1955 PITTWATER ROAD, BAYVIEW

S4.55 AMENDED PLANS

DRAWING LIST

Entry Floor Plan

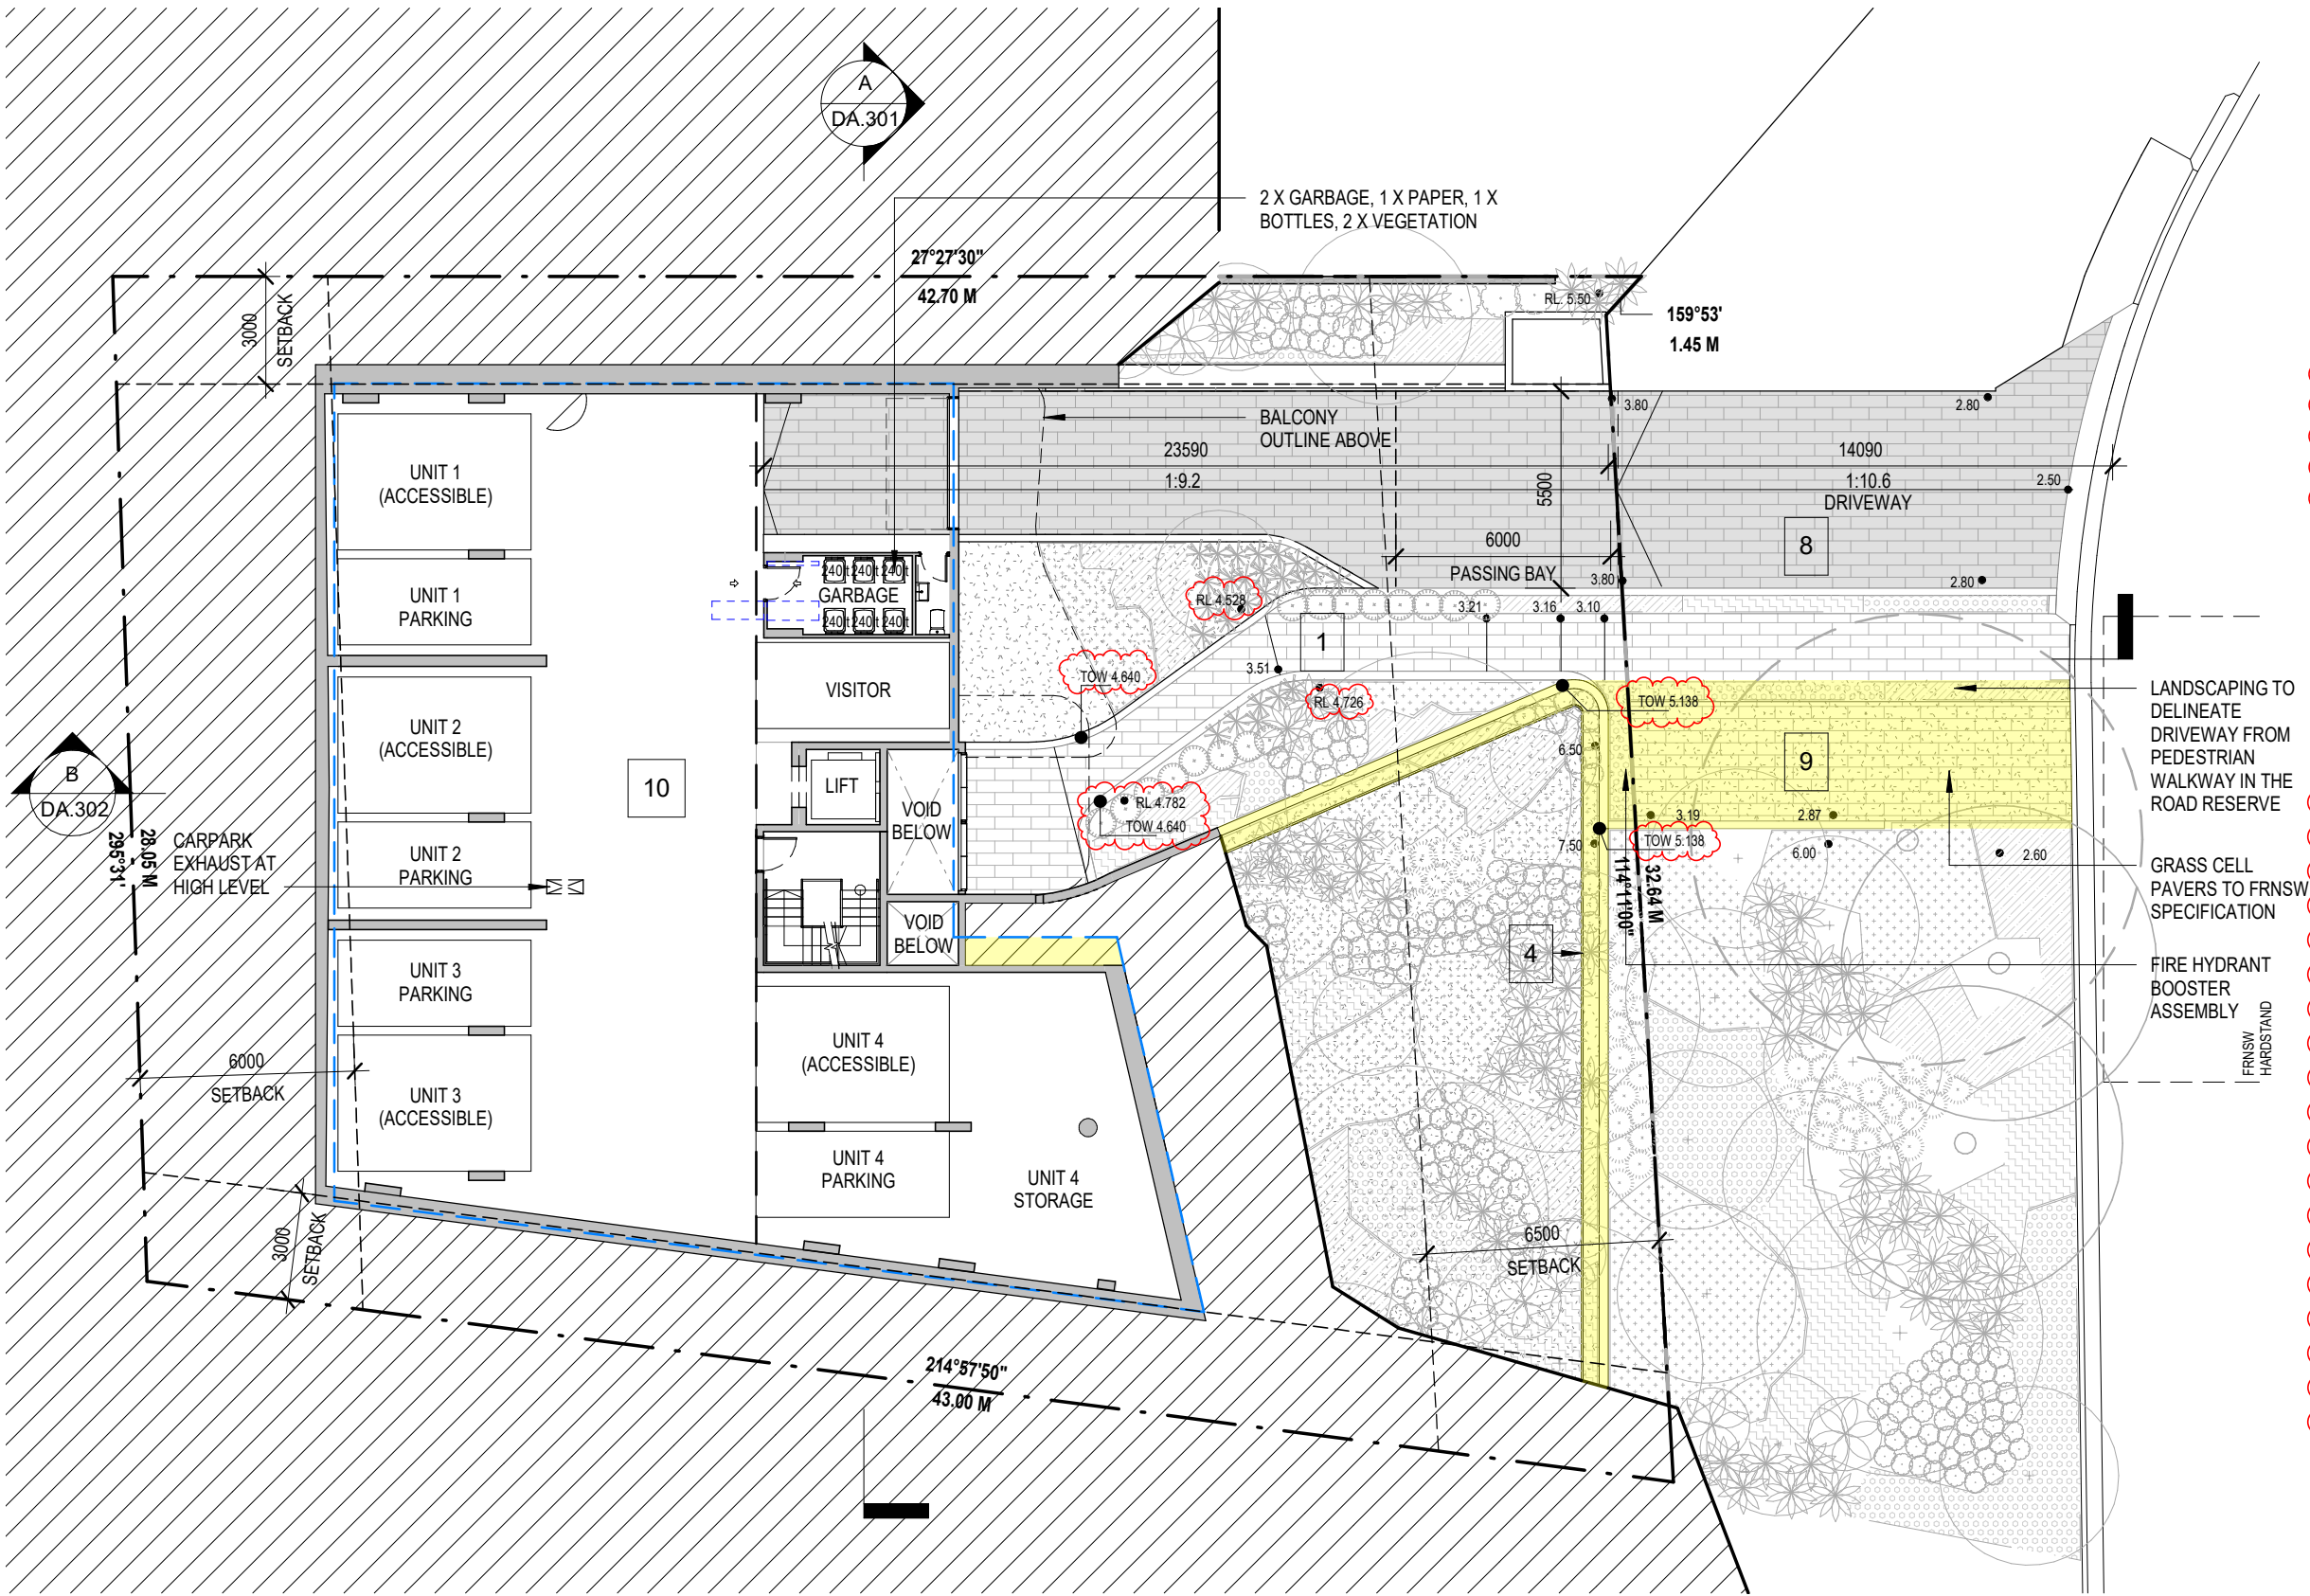
1. **Entry Pedestrian Ramp** - Increased pedestrian ramp width to 1600mm for accessibility
2. **Building Entry** - New awning and vertical louvre screen to increase sense of entry.

3. **Balcony Articulation** - New curved balconies for improved aesthetics. Increase in outdoor private open space area and solar access for improved amenity

4. **Fencing** - New fencing to provide safety and security
5. **Roof** - New rooftop plant enclosure to comply with services requirements
6. **First Floor Roof Deck/ Landscaping** - Change in configuration of First Floor roof deck to integrate with overall building aesthetics. New landscape buffer around perimeter of First Floor roof deck for improved privacy and softening of built form

7. **Roof & Floor RL** - Adjustment in floor-to-floor heights to reflect structural and building services requirements.
8. **Vehicular Access** - Design development to comply with accessibility & Australian Standards.

9. **FRNSW Requirement** - to provide hardstand & fire hydrant booster assembly , requiring removal of tree T3 (Refer to Arborist Report).
10. **Carpark Floor Plan** – Parking re-configuration within approved footprint.

11. **Lower Ground Floor Plan** – Increase in Unit 4 storage area to accentuate recess and alignment between the two modulated built forms. Louvred door and panels for maintenance and ventilation. New landscaped terrace to integrate with cascading balconies above and overall building aesthetics.

12. **Unit layouts** - Internal reconfiguration and increase in unit size for improved amenity.
13. **Elevations** - Removal of wall break in east elevation of Units 3 and 4. Revised façade and window treatments associated with plan amendments

14. **Boundary Fence** - 1.8m high painted fencing capped and lapped in Dulux 'Winter Fog'
15. **Vertical Screening** - Continuation of vertical screening over lift shaft to accentuate recess between the two modulated built forms

16. **Proposed Terrace Extension**

Drawing Title
Carpark Floor Plan

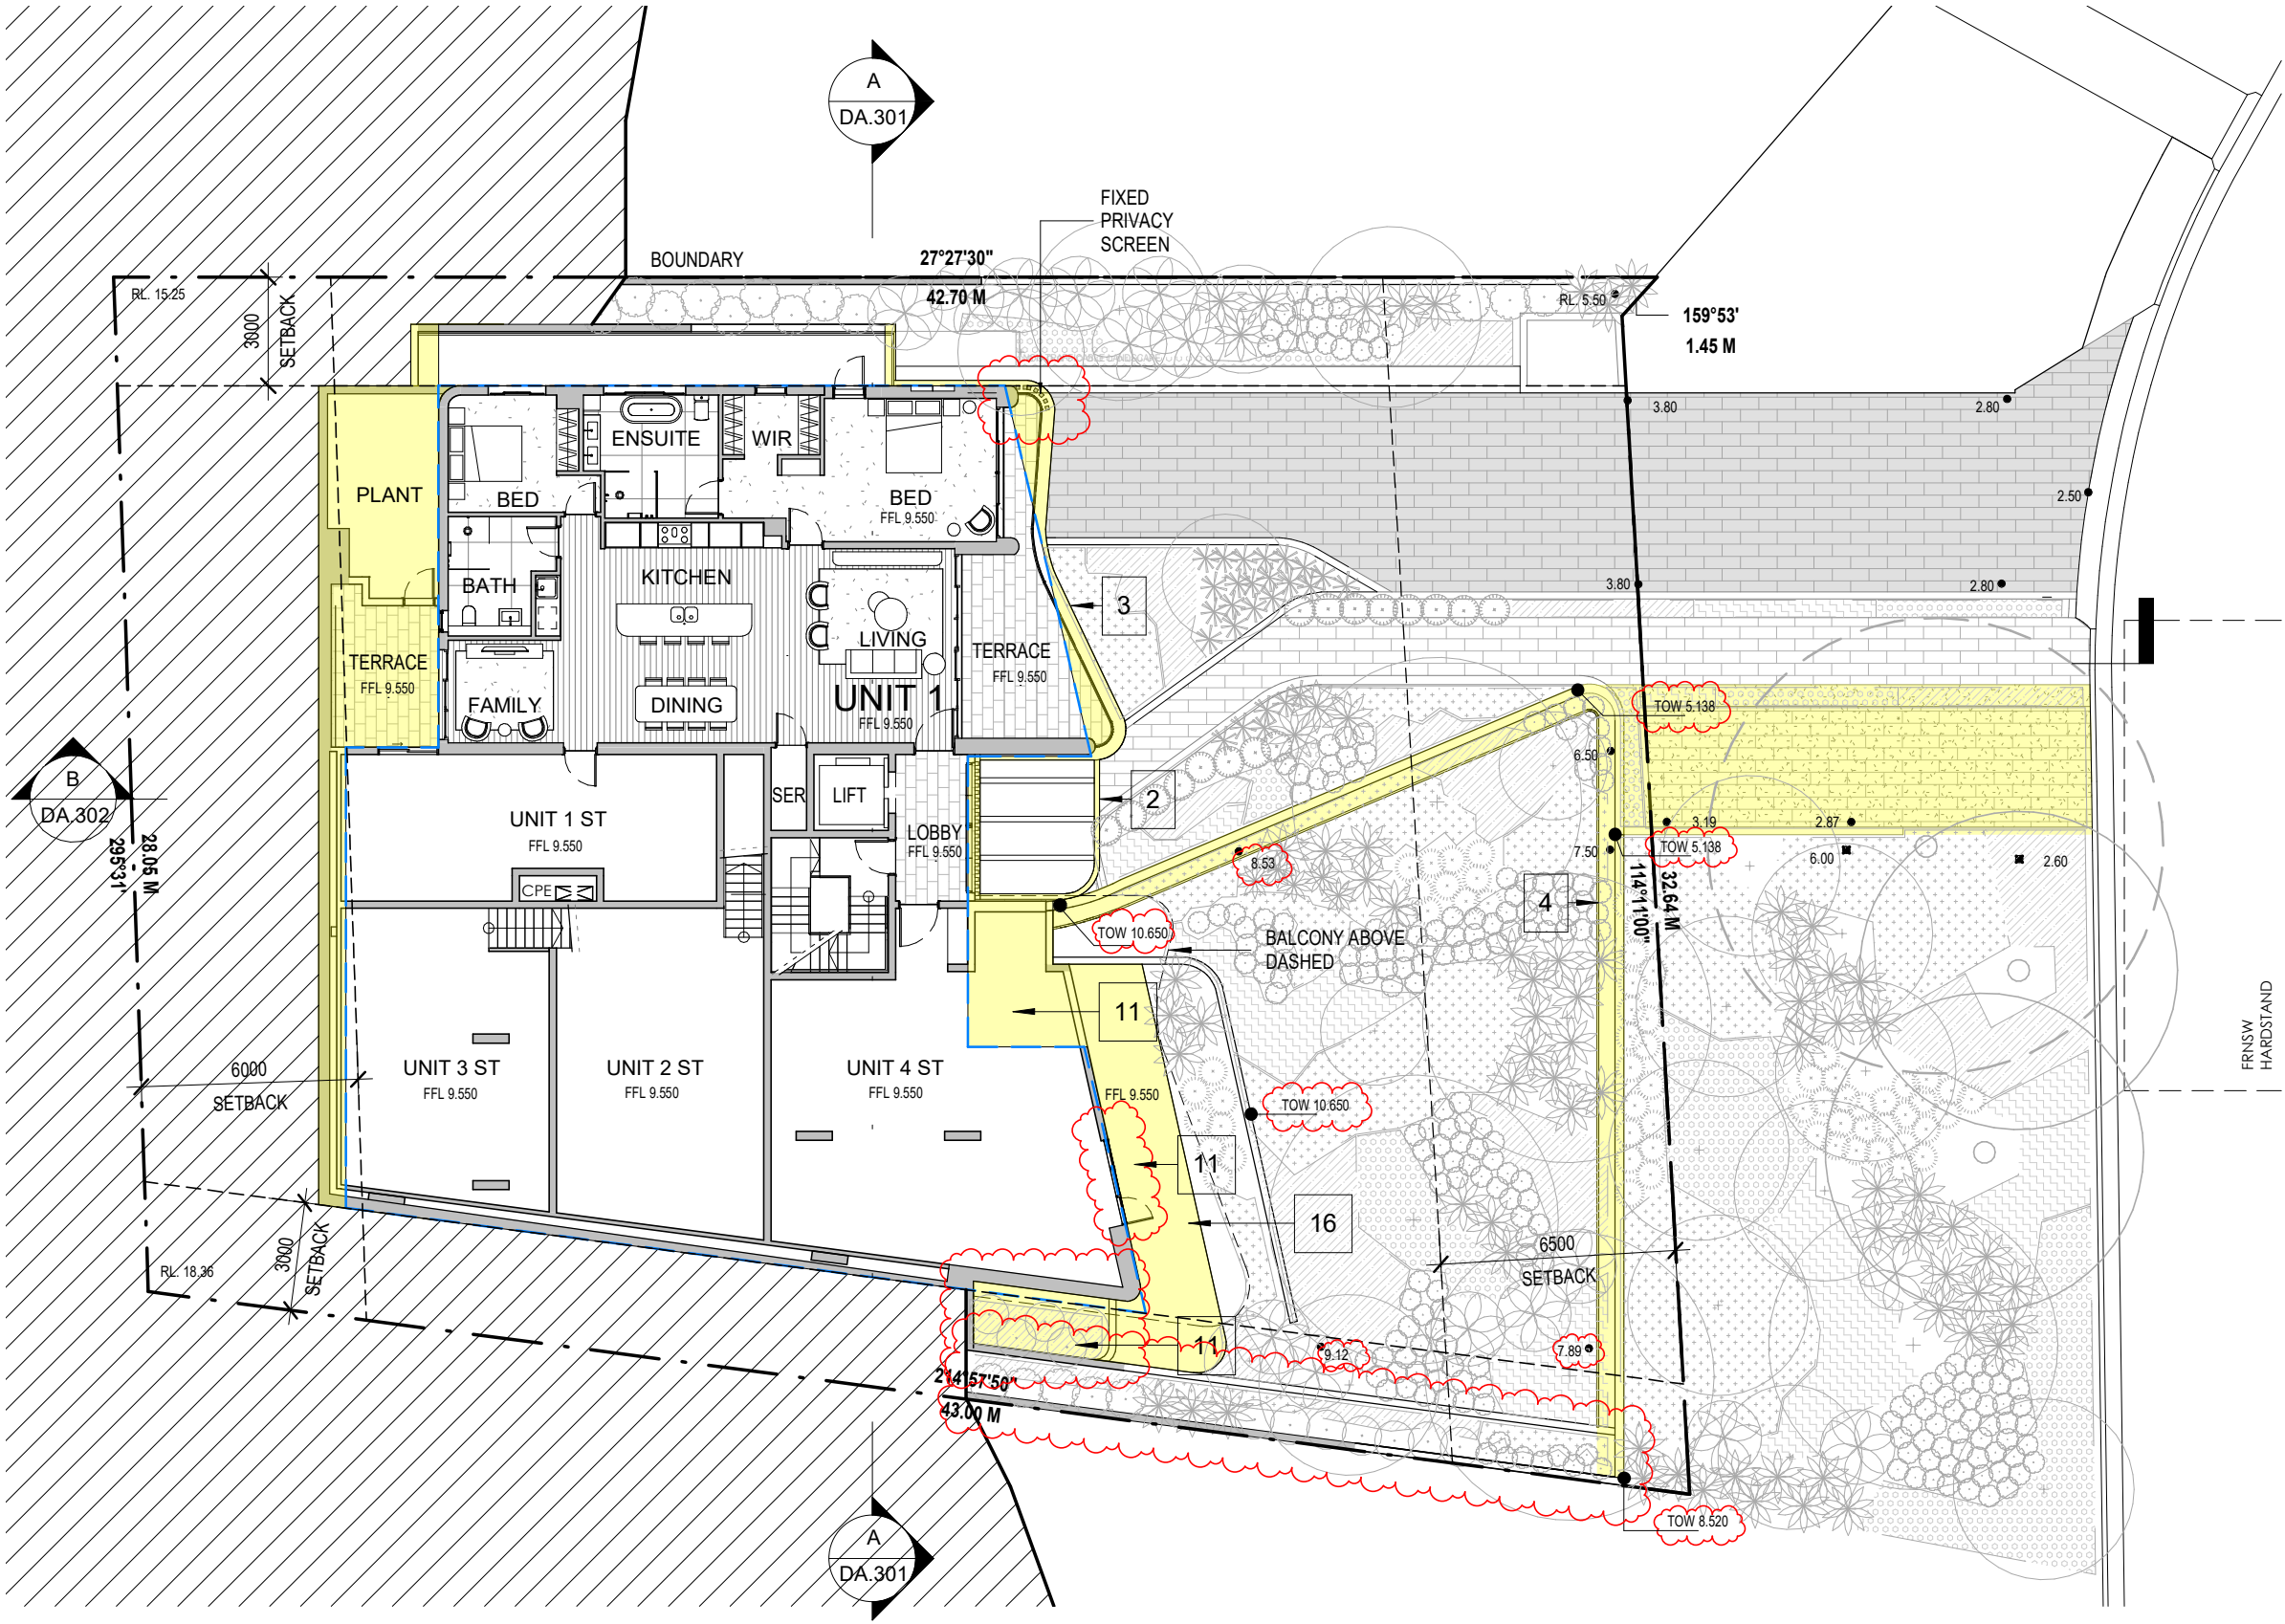
- 1. **Entry Pedestrian Ramp** - Increased pedestrian ramp width to 1600mm for accessibility
- 2. **Building Entry** - New awning and vertical louvre screen to increase sense of entry.

- 3. **Balcony Articulation** - New curved balconies for improved aesthetics. Increase in outdoor private open space area and solar access for improved amenity

- 4. **Fencing** - New fencing to provide safety and security
- 5. **Roof** - New rooftop plant enclosure to comply with services requirements
- 6. **First Floor Roof Deck/ Landscaping** - Change in configuration of First Floor roof deck to integrate with overall building aesthetics. New landscape buffer around perimeter of First Floor roof deck for improved privacy and softening of built form

- 7. **Roof & Floor RL** - Adjustment in floor-to-floor heights to reflect structural and building services requirements.
- 8. **Vehicular Access** - Design development to comply with accessibility & Australian Standards.

- 9. **FRNSW Requirement** - to provide hardstand & fire hydrant booster assembly, requiring removal of tree T3 (Refer to Arborist Report).
- 10. **Carpark Floor Plan** - Parking re-configuration within approved footprint.

- 11. **Lower Ground Floor Plan** - Increase in Unit 4 storage area to accentuate recess and alignment between the two modulated built forms. Louvred door and panels for maintenance and ventilation. New landscaped terrace to integrate with cascading balconies above and overall building aesthetics.

- 12. **Unit layouts** - Internal reconfiguration and increase in unit size for improved amenity.
- 13. **Elevations** - Removal of wall break in east elevation of Units 3 and 4. Revised façade and window treatments associated with plan amendments

- 14. **Boundary Fence** - 1.8m high painted fencing capped and lapped in Dulux 'Winter Fog'
- 15. **Vertical Screening** - Continuation of vertical screening over lift shaft to accentuate recess between the two modulated built forms

- 16. **Proposed Terrace Extension**
